Service Bulletin #: SB11
Title: EX500 Satellite Communicator Software
Field Update

Installation of new satellite transceiver software in the FlightMax EX500.

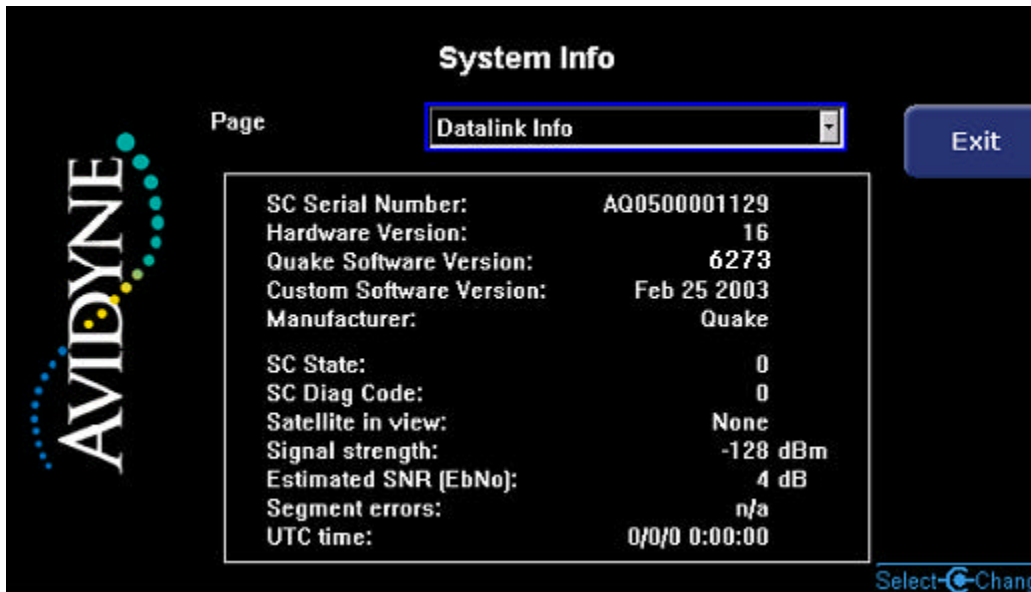
4. _____ Power-up the FlightMax EX500 with the Zip drive attached and disk 510-00085-000 inserted in the zip drive.
5. _____ Verify that after initialization, the following screen is displayed (ARM version may differ; SC version may differ or be dashed)

8. ____ Verify ARM version and SC versions now match the following values.
 - a. ____ SC version matches date Feb 25 2003
 - b. ____ ARM version matches number 4213 if the SC number begins with "DQ" or matches 6273 if the SC number begins with "AQ".
9. ____ If the update procedure fails reattempt the process. If the procedure fails again, call Avidyne Technical Support at 1-888-723-7592
10. ____ Press Exit to close the loader and continue with EX500 start -up.
